*ADMINISTRATIVE DESIGN REVIEW
RECOMMENDATION MEETING*
#3026926
1501 NW 59th St

SITE ADDRESS 1501 NW 59th St
 PARCEL NUMBER 2767604525
 SDCI # 3026926
 APPLICANT Neiman Taber Architects
 1421 34th Avenue, Suite 100
 Seattle, WA 98122
 (206) 760-5550
 CONTACT David Neiman
 dn@neimantaber.com
 ZONING NC3-40
 OVERLAYS Ballard Hub Urban Village
 LOT SIZE 5,000 SF
 ALLOWABLE FAR 3.25 (GFA: 16,250 SF)
 PROPOSED UNITS 52
 PROPOSED PARKING 0
 FREQUENT TRANSIT Yes

SDCI STAFF RECOMMENDATIONS + SUMMARY RESPONSE

PERSPECTIVE: CURRENT PROPOSAL

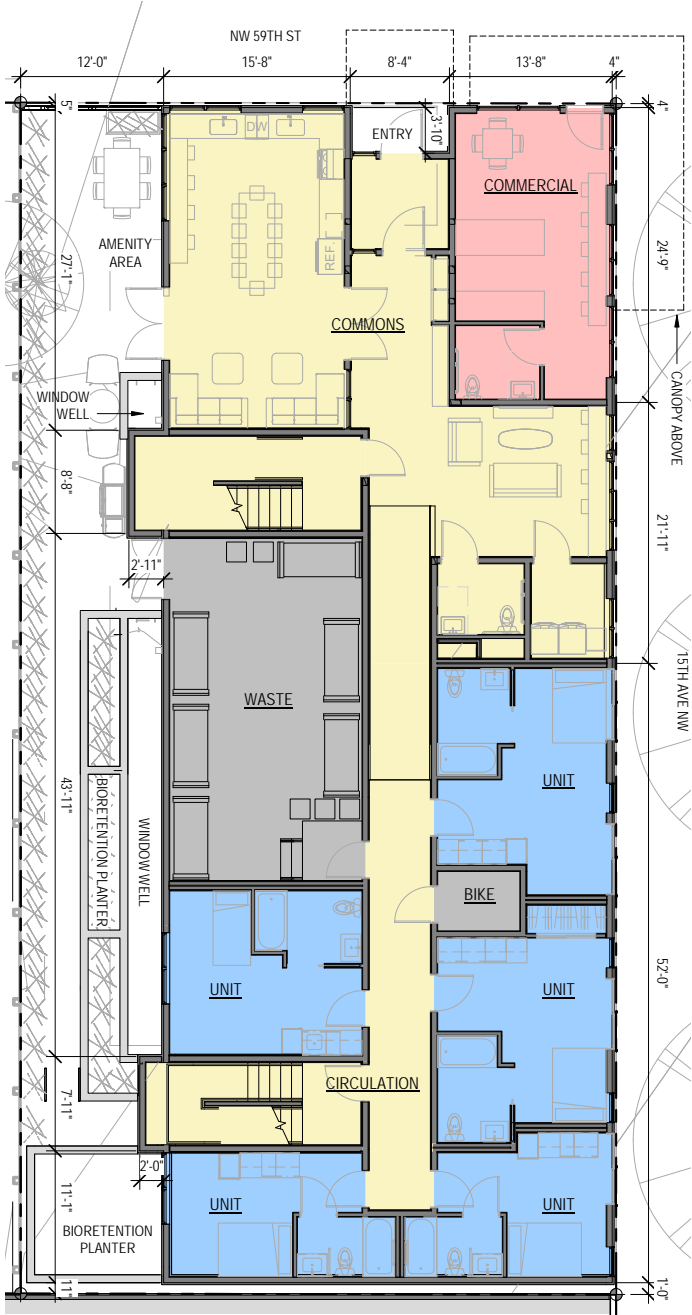
a. Staff supports the use of secondary architectural elements and proposed material changes to provide depth and visual interest to the building façades, especially the east and west façades which are very prominent. The proposed fenestration pattern also works well in creating well-proportioned façades with a clear composition. Staff recommends having the windows wrap the corners of the structure to improve on the composition. *(DC2-B-1. Façade Composition, DC2-C. Secondary Architectural Features, DC2-C-1. Visual Depth and Interest)*

b. Explore opportunities for modulation and/or a vertical expression relating to the circulation elements on the east and west façades to help break up the massing and bulk of the structure. *(DC2-A-2. Reducing Perceived Mass)*

c. Staff supports utilizing a material palette consisting of high quality materials that fit in with the character of the neighborhood. This is extremely important as the success of the proposed massing and fenestration pattern is contingent on the use of high quality materials to complement the simplistic form. Refer to the precedent images in the EDG packet demonstrating how high-quality materials can be used to create a contemporary design that fits into the neighboring context. *(CS3-A-1. Fitting Old and New Together, DC4-A-1. Exterior Finish Materials)*

Juliet balconies paired with large operable opening are used on the east facade as to provide depth. The facade uses a pattern of colored, fine grain materials through out to create visual interest. The windows are now wrapping the corner with additional windows added on the north facade as requested.

The circulation has been pushed out slightly at level 1 and a small portion of level 2 on the west façade. Windows have been added to the circulation and the siding has been aligned to provide visual relief along the west façade. There is no circulation of the east façade, but at the proposed commons a full balcony (instead of a Juliet) and larger amount of fenestration has been added.

James Hardie Reveal, a premium fiber cement product, is proposed for use on the streetside façades. The Reveal siding is a thicker, smoother panel that lays flatter on the wall and has a recessed, extruded flashings that have stronger shadow lines and reads more like an open joint rainscreen than conventional Hardie products.

PLAN: CURRENT PROPOSAL

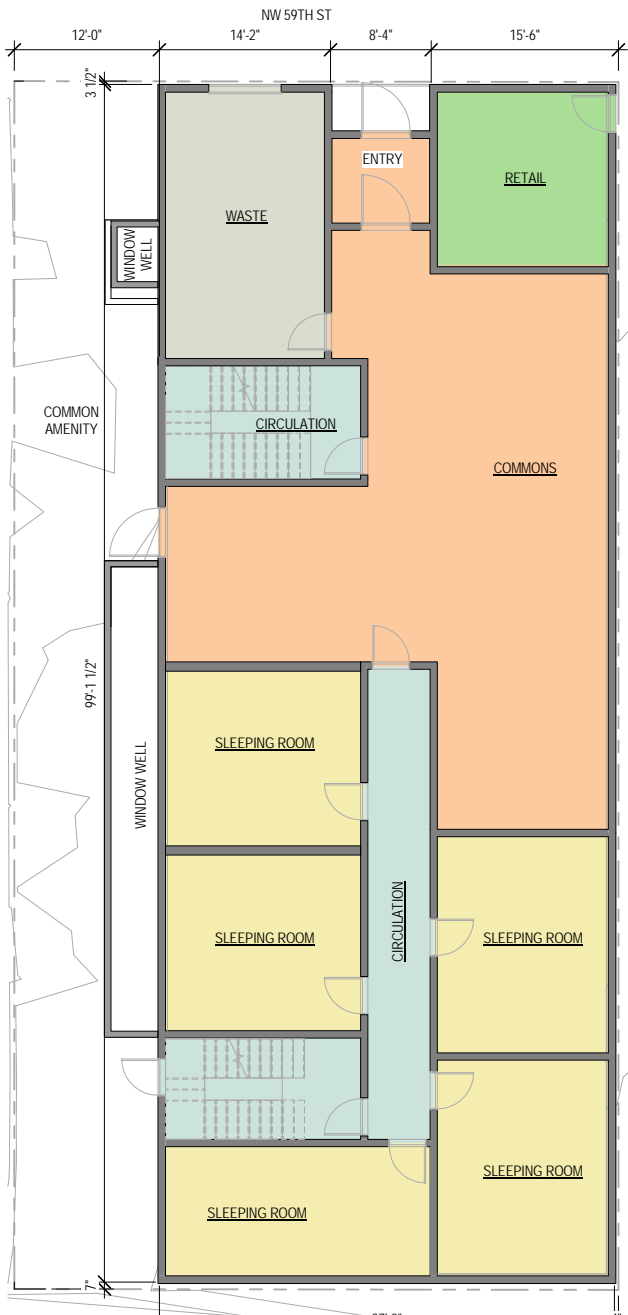
3. Recycling/Waste Room Location: Staff is concerned with the proposed location for the recycling and waste room which is prominently located along NW 59th Street. Staff supports locating this room south of the adjacent stair tower and rearranging the common space to front NW 59th Street near the primary residential entrance. (DC1-C-4. Service Uses)

The waste room has been moved south of the adjacent stair tower as requested. Additional common areas have been moved to the NW corner along NW 59th Street, creating a more active and transparent façade.

PLAN: CURRENT RETAIL SPACE

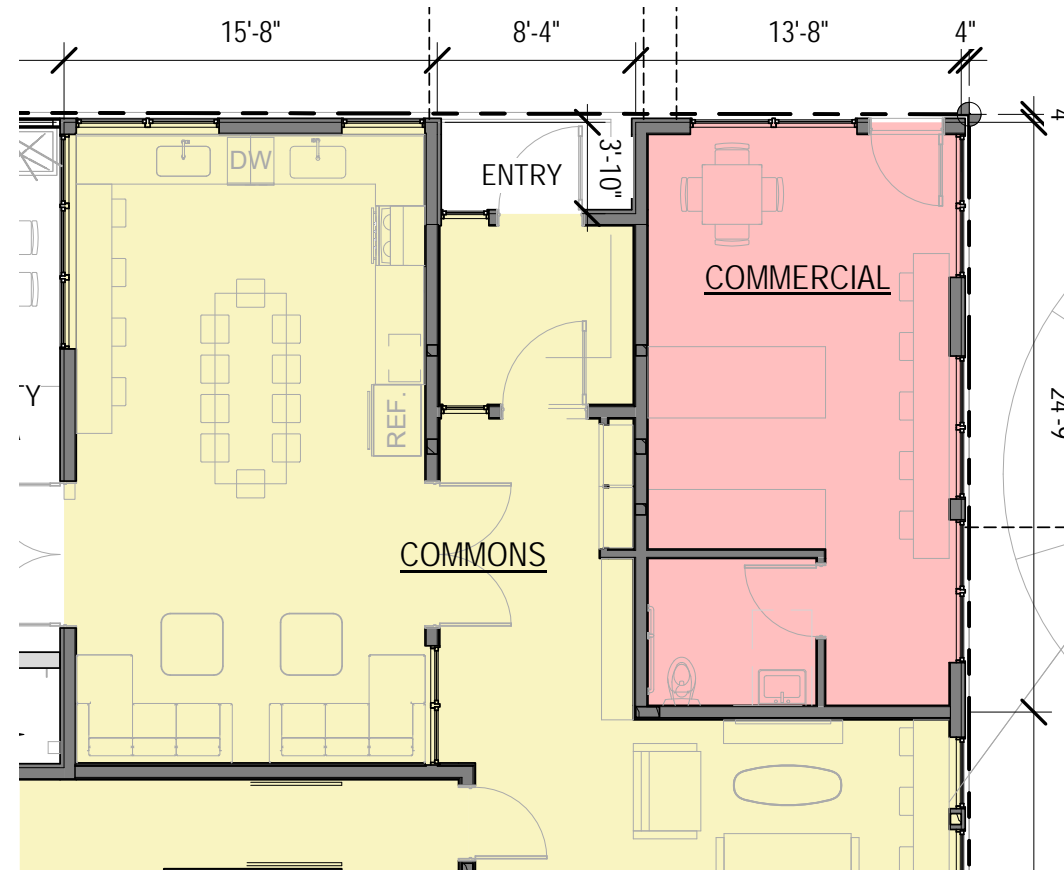
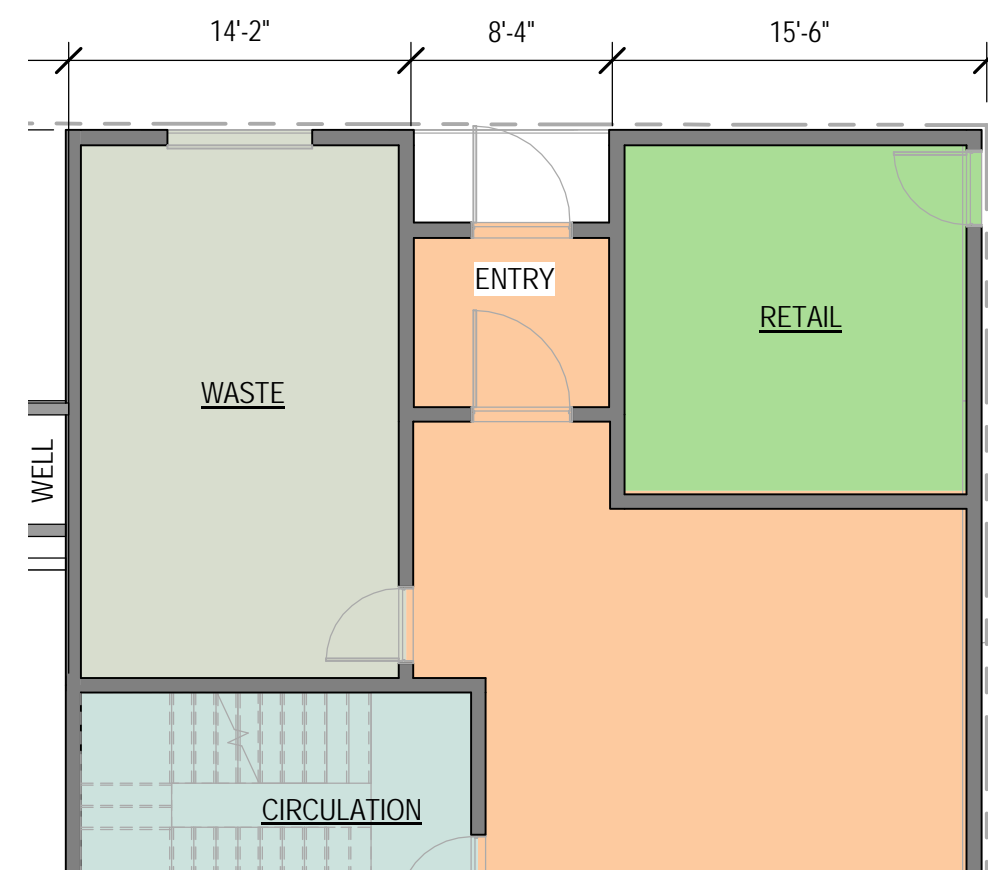
a. Staff is concerned with the functionality of the small size of the micro retail space on the ground floor as proposed. Provide a floor plan showing a potential layout of the commercial space to demonstrate how it can accommodate a retail use. (DC1-A. Arrangement of Interior Uses)

b. Staff is concerned with the fenestration pattern as shown for the commercial space and ground floor commons that front 15th Avenue Northwest. Develop a design that reinforces the prominent base concept while providing a high level of transparency and the opportunity for street level interaction and engagement. (CS2-B-2. Connection to the Street, PL3-B-4. Interaction, PL3-C-2. Visibility, DC1-A-4. Views and Connections)

The small retail space has been enlarged by ~50%. A potential layout has been added to demonstrate how it can be used to accommodate a small retail use.

The fenestration pattern at the ground floor commercial space has been changed to provide more transparency. The commercial and residential commons portion of the base are distinguished from the residential portion by a higher level of transparency, change siding color, and a matching window frame color.

PERSPECTIVE: PROPOSED AMENITY AREA

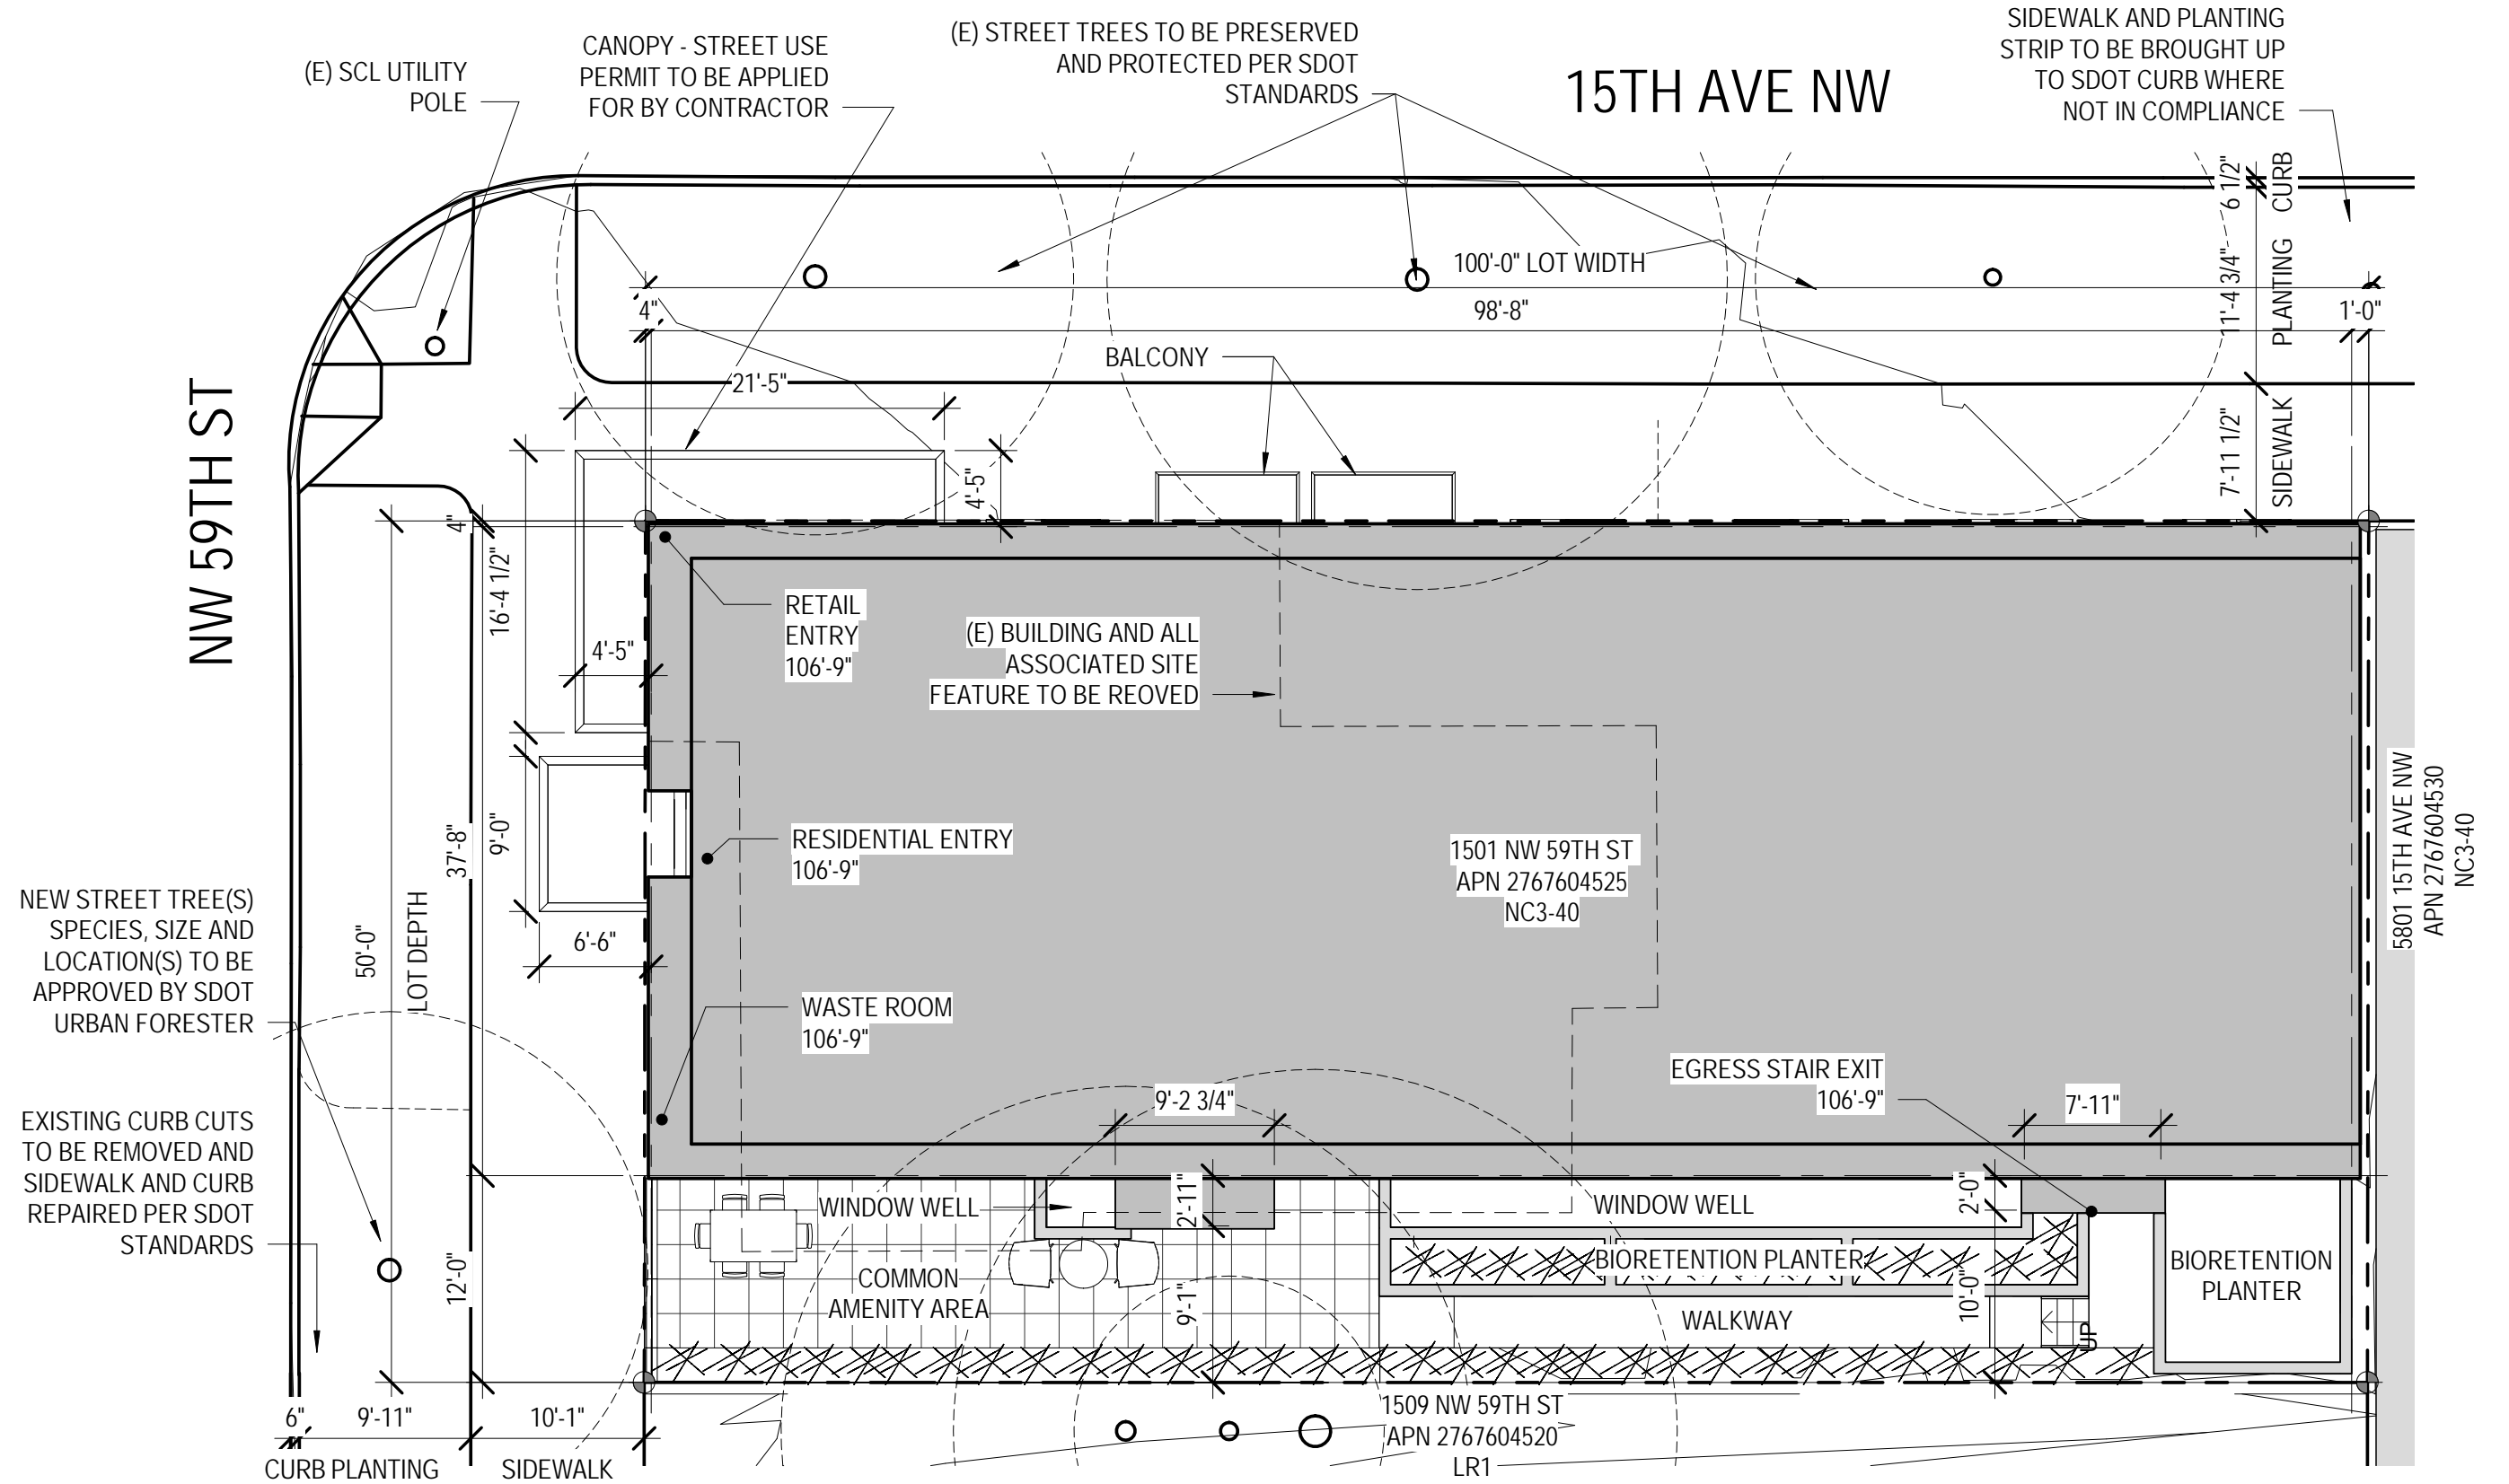
5. **Common Amenity Area:** Staff is concerned with potential design and layout of the common amenity area located east of the structure adjacent to the residential zone. Develop a design that will contribute to the overall usability of this area and include vegetation that is vertical in nature to help buffer the structure from the adjacent properties. Hardscape materials can also be used to add color and texture to the open area and delineate a pedestrian pathway. *(DC3-B-1. Meeting User Needs, DC4-D-1. Choice of Plant Materials, DC4-D-2. Hardscape Materials)*

A more refined design has been developed. Vegetation that is vertical in nature, Green Tower Boxwood, along the length of the west property to buffer the amenity area from adjacent neighbor. Permeable paver hardscaping has been added to delineate the walkways and patio.
